RP-1202 PUMP, 2:1 RATIO

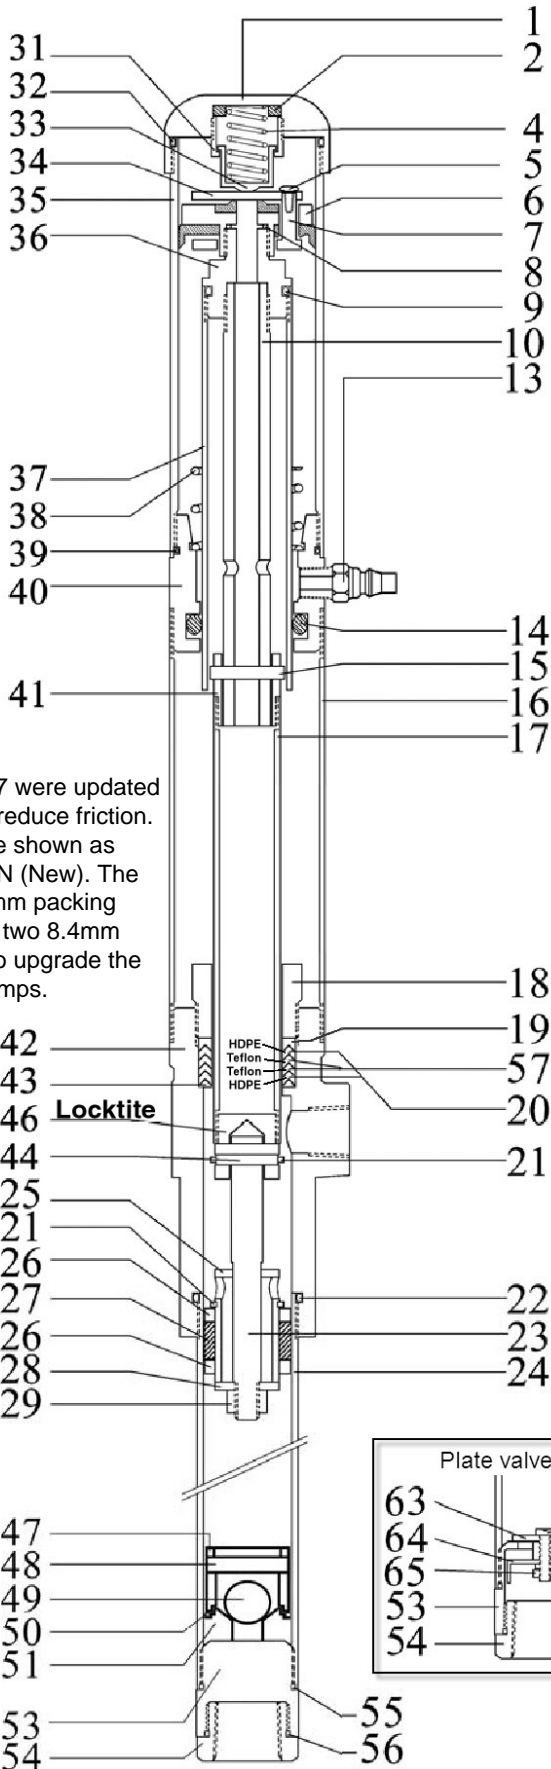
* 26 & 27 were updated 2018 to reduce friction. Parts are shown as RP1202N (New). The new 10mm packing requires two 8.4mm glands to upgrade the older pumps.
